737

Service Bulletin

Number: 737-53A1251
Original Issue: June 03, 2004
Revision 2: January 20, 2021
ATA System: 5311

SUBJECT: FUSELAGE - Frames and Bulkheads - Body Station 1016 Aft Pressure Bulkhead -
Apex Inspection

**FIGURE 1: AFT PRESSURE BULKHEAD - WEB LAP SPLICE INSPECTION AREAS
(SHEET 1 OF 2)**

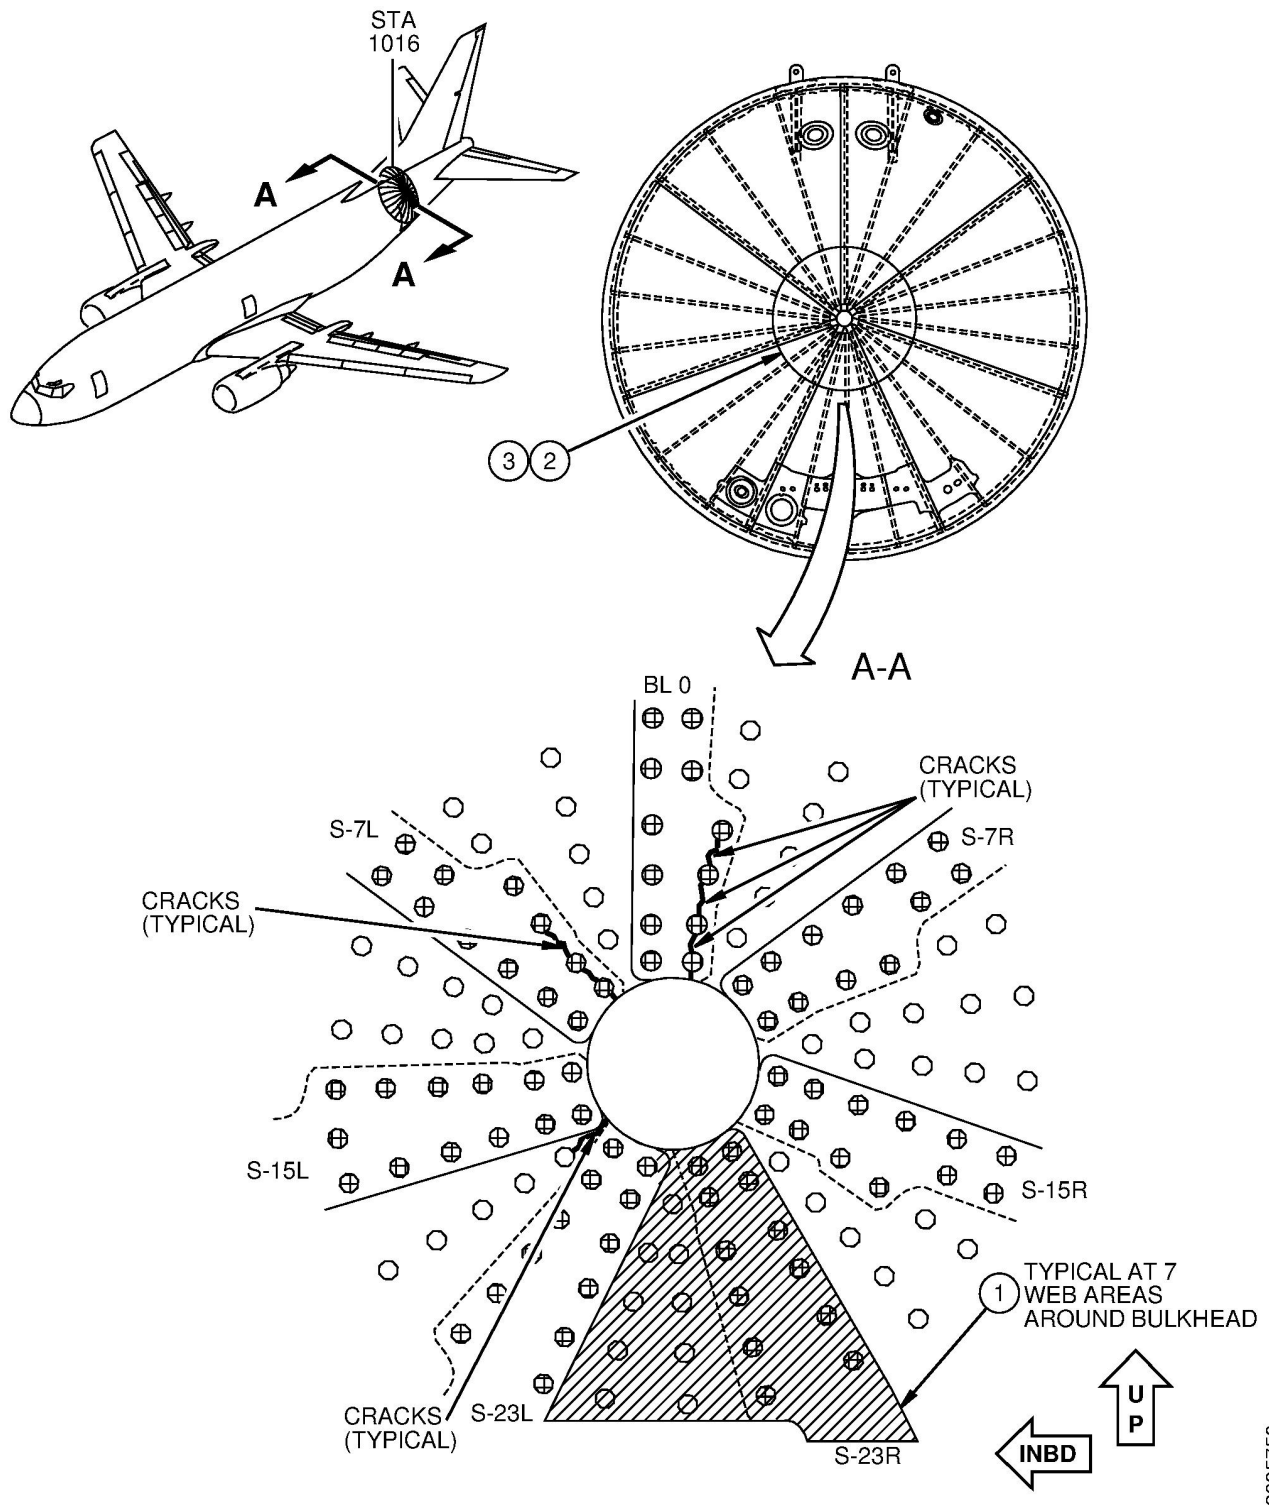
This revision is sent to update Group 1 compliance time and for Group 1 removed GVI for any repair.

1. In Summary and 1.D Description, updated Group 1 Actions.
2. In Paragraph 1.E., Compliance, updated compliance tables 1 and 2.
3. In 1.G Manpower, removed figure 2 for Group 1.
4. In Paragraph 3.B.2, Work Instructions, updated to match compliance tables 1 and 2.
5. Figure 2, was deleted.

Do a Detailed Inspection and a HFEC Inspection around the web fasteners for any crack. Do a LFEC Inspection around the hidden web lap splice fastener locations for any crack. If no crack is found, continue to do the repeat Detailed Inspection, HFEC Inspection and LFEC Inspection, at the times specified in the compliance section of this service bulletin. If any crack is found, contact The Boeing Company for repair instructions and do the repair.

1. Get access to the aft side of the Aft Pressure Bulkhead (APB) through the section 48 access and blowout access door, refer to 737-600/700/800/900 AMM 52-49-11 as an accepted procedure.
2. Do a Detailed, High Frequency Eddy Current (HFEC) and Low Frequency Eddy Current (LFEC) Inspections of the aft side of the Aft Pressure Bulkhead (APB) for any crack in accordance with FIGURE 1.
 - a. CONDITION 1: ANY CRACK FOUND.

APPENDIX A: LOGIC DIAGRAM FOR PARAGRAPH 1.E., COMPLIANCE, TABLE 1: INSPECTION OF AFT PRESSURE BULKHEAD CENTER DOME APEX GORE WEBS
(SHEET 1 OF 2)

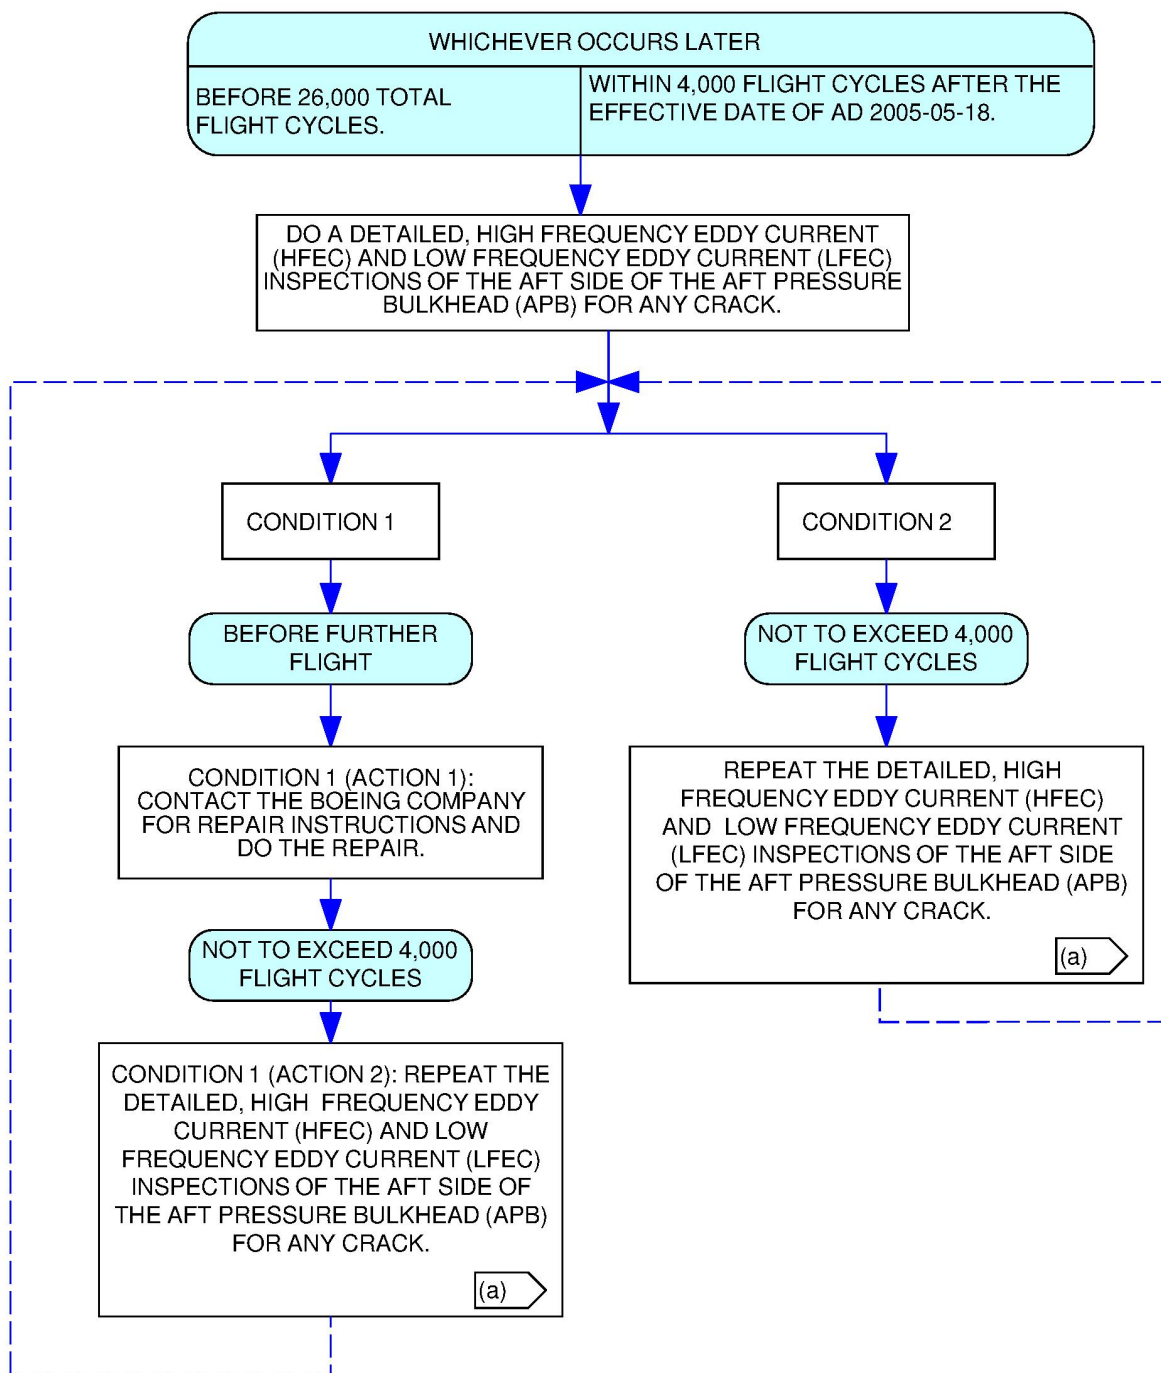
6. APPENDIX A and B, updated logic diagrams for compliance tables 1 and 2.
